Technical Evaluation Report

For H-Area Tank Farm Facility,
Savannah River Site, South Carolina

Final Report

U.S. Nuclear Regulatory Commission
Office of Federal and State Materials
and Environmental Management Programs
Washington, DC 20555-0001

Figure 4-1 Intruder Well Locations at the 1-m (3-ft) Boundary (Inner Boundary Grouped in Sectors A–F) and Within the 1-m (3-ft) Boundary (Yellow Squares)

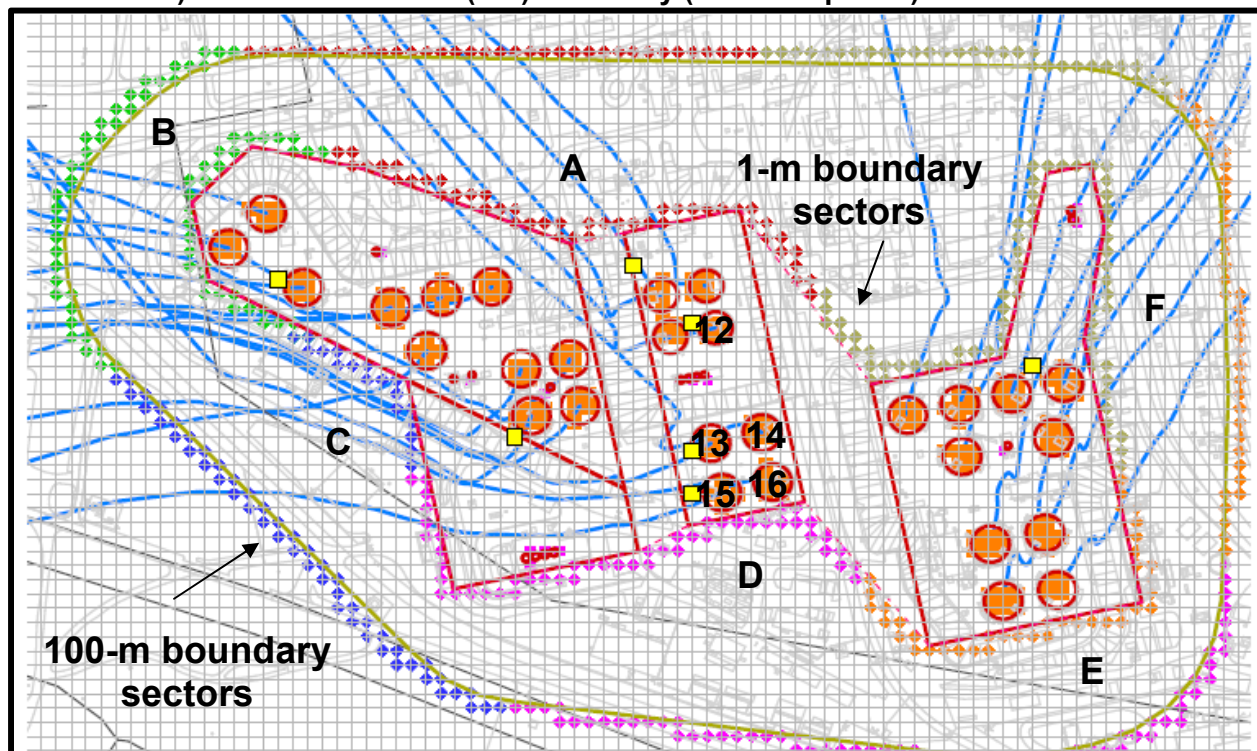
Furthermore, the intruder dose reported on Figure 6.5-6 of the HTF PA (Page 776; SRR-CWDA-2010-00128, Rev. 1) for a well located within the 1-m boundary directly downgradient of Tank 13 is not the highest “1-m Boundary” intruder dose reported on the figure. The peak intruder dose reported in the HTF PA is associated with a well located within the 1-m boundary adjacent to Tank 12 (see yellow square to the left of Tank 12 in Figure 4-1). The Tank 12 intruder well dose is an order of magnitude higher than the dose reported for Tank 13 (Page 776; SRR-CWDA-2010-00128, Rev. 1). The HTF PA intruder simulations show the sensitivity of the results to exposure point locations (see Section 4.2.16). Notwithstanding the intruder doses reported in the HTF PA, because final inventories for HTF tanks and other components have not yet been developed, the intruder well location that represents the most limiting case with respect to protection of the inadvertent intruder and consequently, the waste classification, is not yet known.

Figure 4-18 GSA/PORFLOW™ Model Residuals Near H-Area

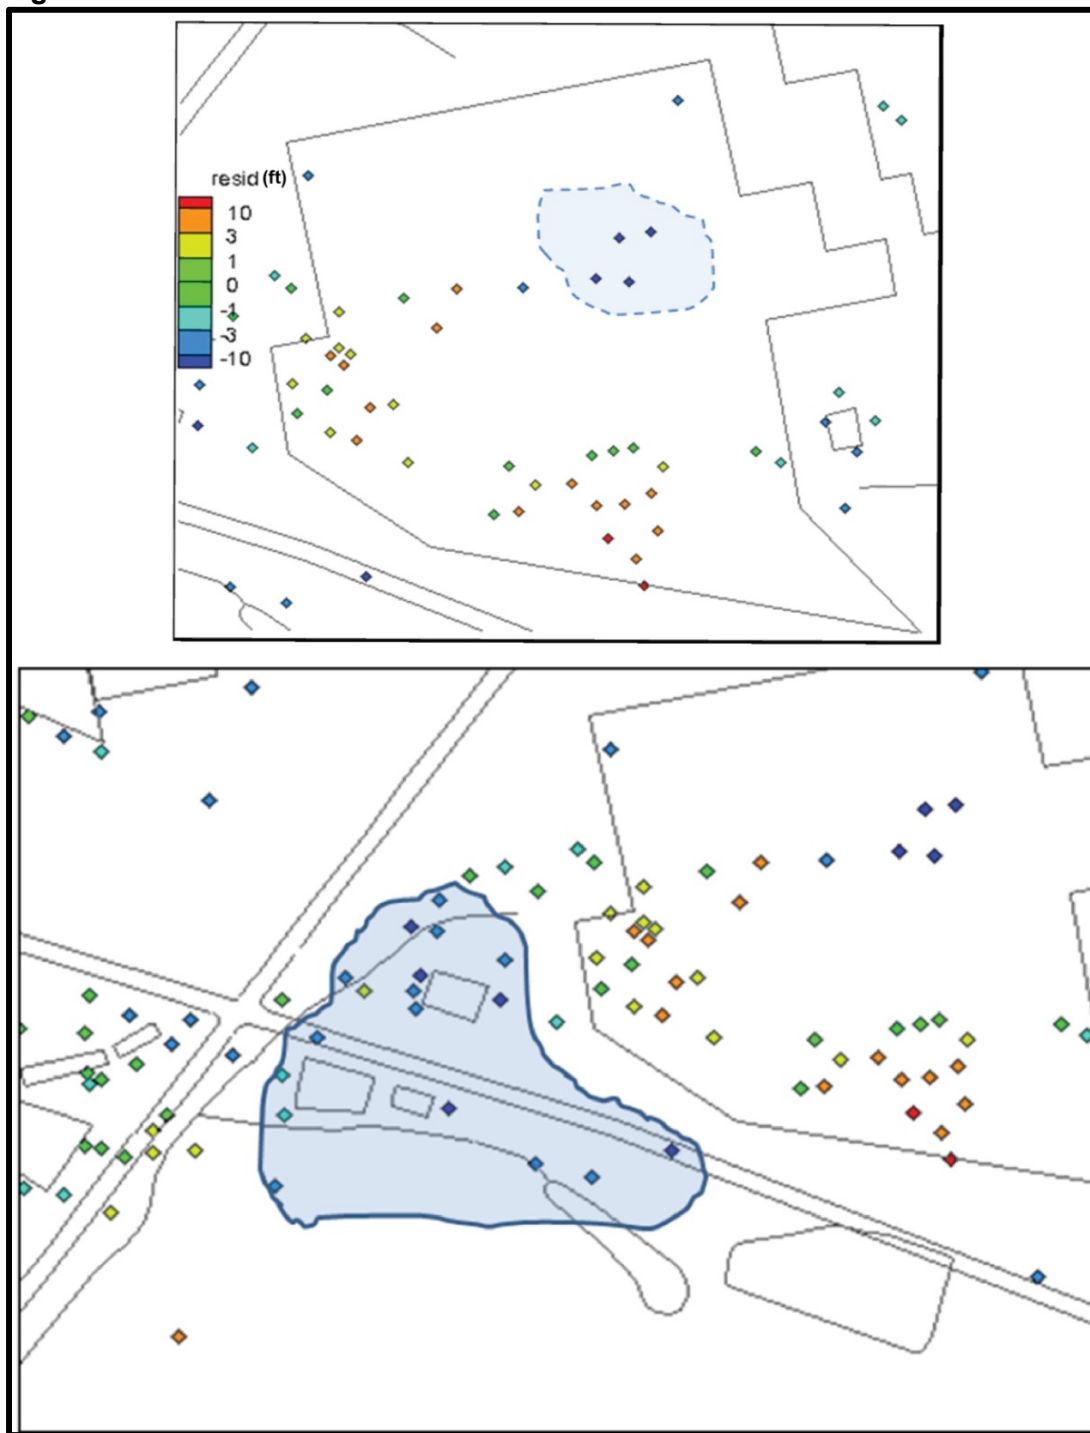
Based on the updated study, DOE identifies two areas that could benefit from additional model calibration: (1) an area north of HTF (near H-Canyon) and (2) an area southwest of HTF (see Figure 4-18). Both areas had modeled heads that were under-predicted by 6 ft (2 m) or more from the calibration targets. Additionally, the GSA/PORFLOW™ model tended to over-predict head by more than 10 ft (3 m) at HTF (see Figure 4-18). In other words, modeled head is generally too high at HTF and too low along groundwater flow pathways away from HTF. Therefore, the horizontal hydraulic gradient in the UTRA-UZ appears to be significantly less than modeled based on more recent data and adjustments made to hydraulic conductivities during model calibration (1) may not have been needed and (2) may not be appropriate.

HTF are artificially high, whereas modeled hydraulic heads in outlying portions of H-Area are artificially low (Figure 4-18). The overall consequences to dose estimates due to inadequate flow and transport representation in the vicinity of H-Area are difficult to assess.

Figure 4-19 Source Cells Plotted from PORFLOW™ Input Files

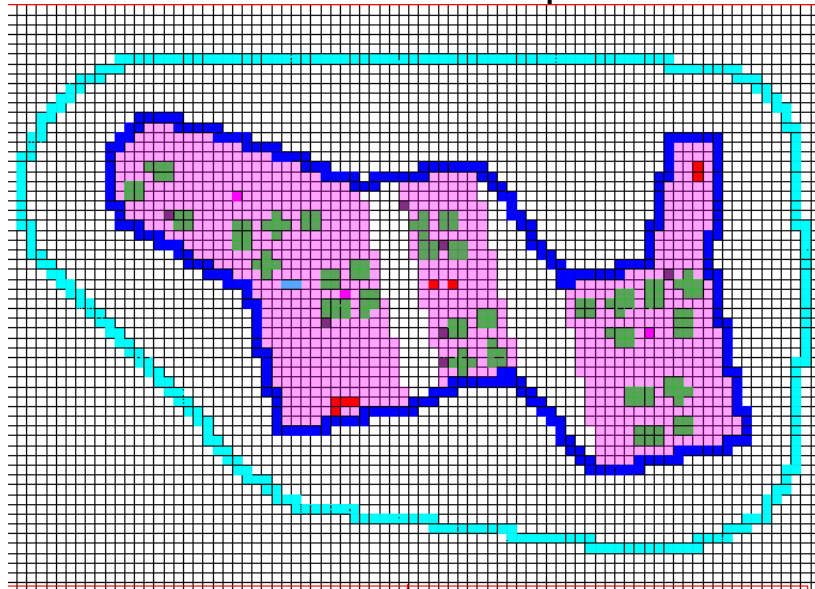
Upon comparing source cells that are illustrated in Figure 4-12, which is reproduced from the HTF PA, to source cells that are listed in HTF/PORFLOW™ input files and plotted by the NRC staff in Figure 4-19, there are significant differences in the number of source cells to which the flux is applied. The NRC staff's review of DOE's RAI-NF-14 response (SRR-CWDA-2013-00106, Rev. 1), confirms that HTF PA Figure 5.2-5 from which Figure 4-12 is adapted is in error and the HTF/PORFLOW™ input files plotted by the NRC staff reflect the actual modeled source cells. In any event, the number of source cells used in the modeling influences the starting concentration of key radionuclides in the aquifer. Additionally, given the strong vertical gradient at HTF and the apparent differences in flow direction in the upper and lower zones of the UTRA, the elevation of source loading may also significantly influence the degree of vertical spreading and the modeled level of dispersion and dilution in the aquifer.

While DOE indicates that results are not sensitive to source loading assumptions (SRR-CWDA-2010-00128, Rev. 1), DOE appears to have evaluated the sensitivity of the results to a range of source cells different from what was actually used in the PORFLOW™ modeling. Additionally, DOE attributes differences in path lines presented in Figures 5.2-6 (correct) and 4.4-13 (incorrect) in the HTF PA (SRR-CWDA-2010-00128, Rev. 1) to slight differences in the assignment of velocity vectors in plotting software, further suggesting the potential sensitivity of the results to slight changes in the flow field or source loading locations. Finally, the grid cells in the upper zone of the UTRA have a coarser vertical discretization compared to the lower zone of the UTRA and it is not clear whether eastern source cells are loaded above the water table, based on Figure RAI-NF-14.2 in SRR-CWDA-2013-00106, Rev. 1.

Figure 4-21 GSA/PORFLOW Residuals in Feet for the (a) UTRA-LZ and (b) UTRA-UZ

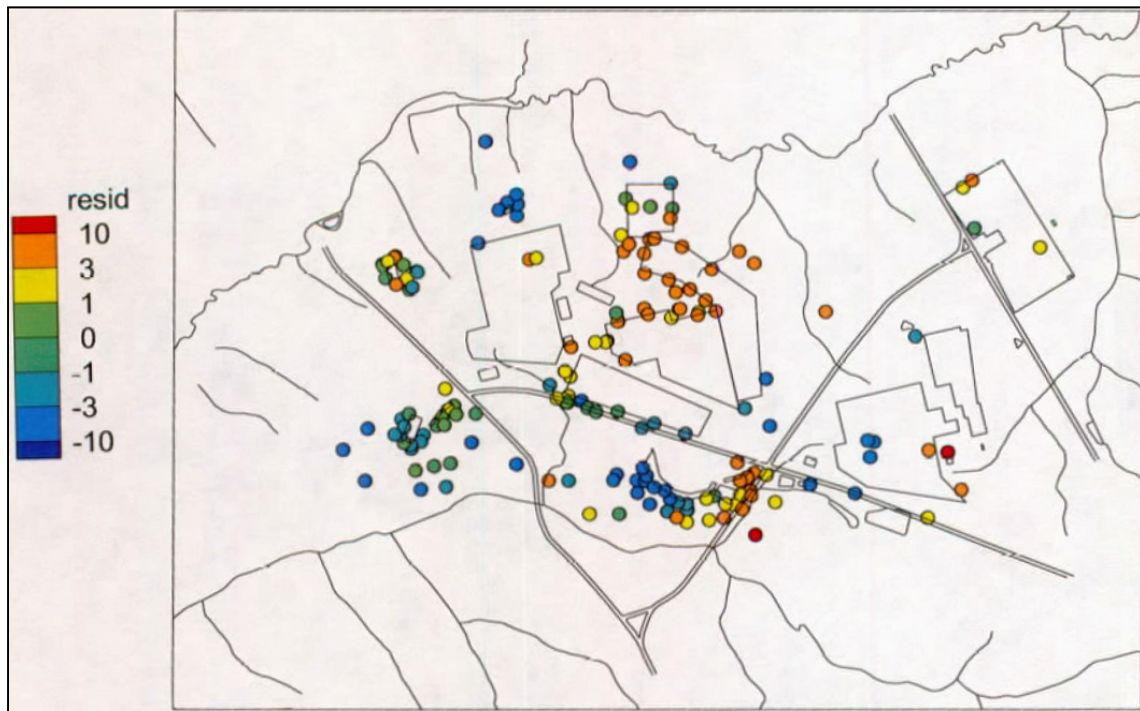
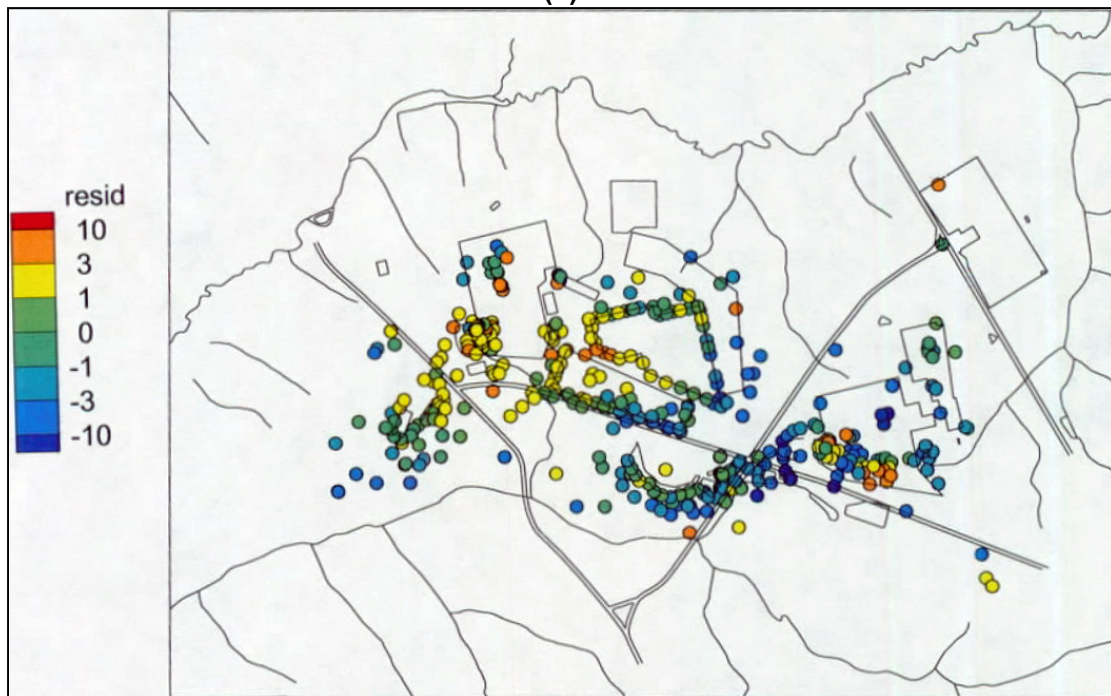
removed in the revised study, and no UTRA-LZ data are provided, although high residuals in the UTRA-LZ are reported in the GSA/PORFLOW model documentation (WSRC-TR-2004-00106, Rev. 0) [see Figure 4-21(a)]. Finally, data are clustered [see Figure 4-20(b)] leading to inequitable spatial weighting of calibration targets with some locations dominating the results. If observed versus modeled water levels are plotted, the plot would show that the errors are not random but are spatially biased with high calibration target areas too high and low calibration target areas too low in the UTRA-UZ, leading to significant error in the hydraulic gradient at HTF.

Figure 4-29 Scatter Plots of Peak Dose Versus Time (All Cases 20,000-Year Model*)

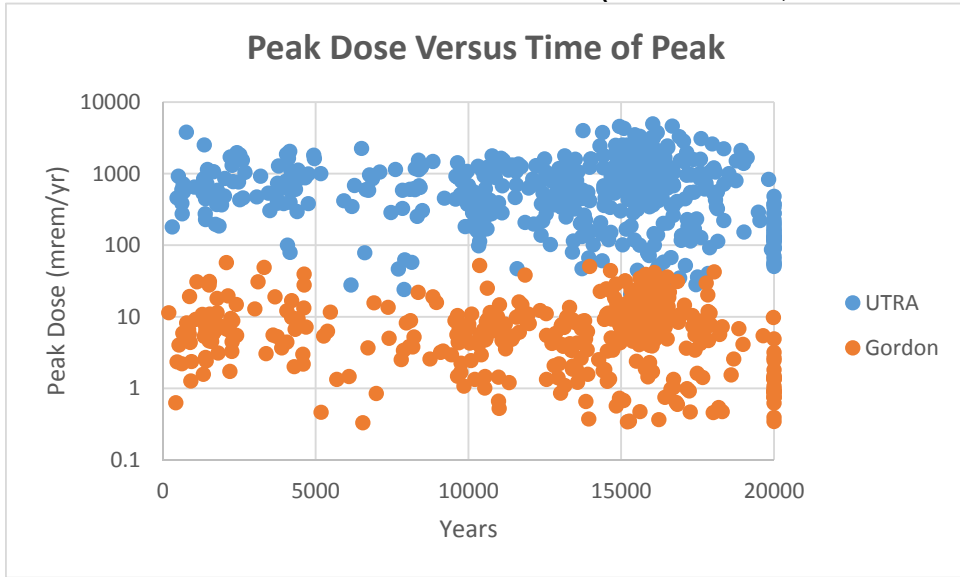
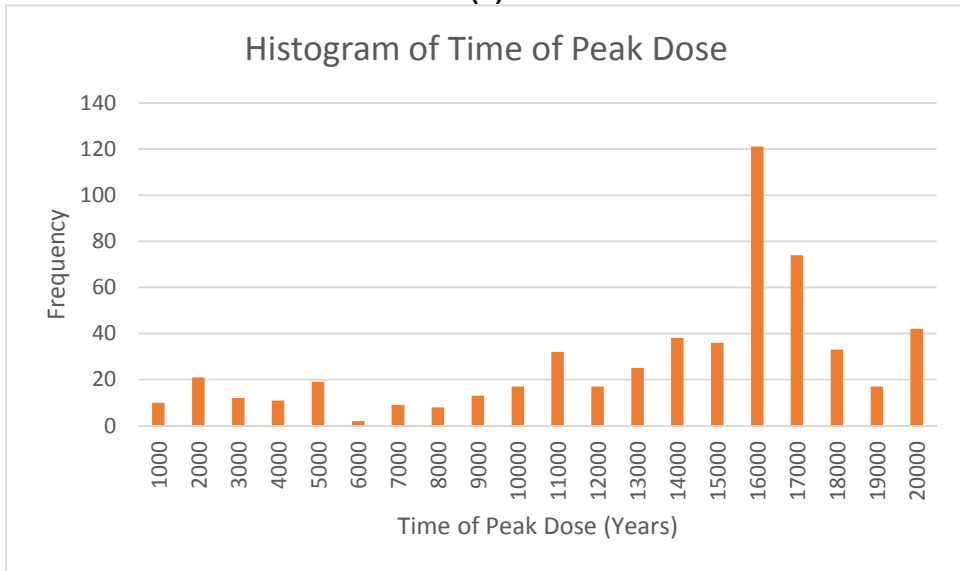
The NRC staff extracted output from DOE's probabilistic GoldSim™ model to produce scatter plots of peak dose versus time in Figures 4-29 and 4-30 for the "All Cases" probabilistic model run for a 20,000- and 100,000-year simulation period, respectively. Figure 4-29(a) shows two sets of realizations that are similar in shape but that differ by the magnitude of the peak dose with the bottom set representing results for the Gordon Aquifer that is nominally set at a value of 100 times less than the dose computed for the UTRA. A comparison of the peak dose versus time for a 20,000-year simulation period reveals that the average peak dose is 8.9 mSv/yr (890 mrem/yr) when the Gordon Aquifer wells are removed compared to an average peak dose of 5 mSv/yr (500 mrem/yr) for all realizations or approximately 44 percent less, as expected. A comparison of the peak dose versus time for a 100,000-year simulation period reveals that the average peak dose is 9.8 mSv/yr (980 mrem/yr) when the Gordon Aquifer wells are removed compared to an average peak dose of 5.3 mSv/yr (530 mrem/yr) for all realizations. The average time of peak dose is around 13,000 years for the 20,000-year simulation period and around 30,000 years for the 100,000-year simulation period. While all peak doses are greater than around 0.4 mSv/yr (40 mrem/yr) in the 20,000 year-simulation, if the full magnitude of the peak is allowed to occur with a longer simulation period, the lowest peak dose is higher at 1.6 mSv/yr (160 mrem/yr) for the 100,000-year simulation period. Figures 4-29(b) and 4-30(b) show histograms of the time of peak dose for the 20,000- and 100,000- year simulation periods, respectively. Remarkably, every realization with the UTRA selected as the well completion stratum is above the dose limit of 0.25 mSv/yr (25 mrem/yr) for the 10 CFR 61.41 performance objective. The high dose results are accentuated by assumptions regarding loss of technetium solubility control and the discrete failure of the steel liners that lead to exaggerated spikes in the Tc-99 dose. Nonetheless, DOE's probabilistic results show that both the timing and magnitude of peak dose within the compliance period appear to be fairly uncertain.
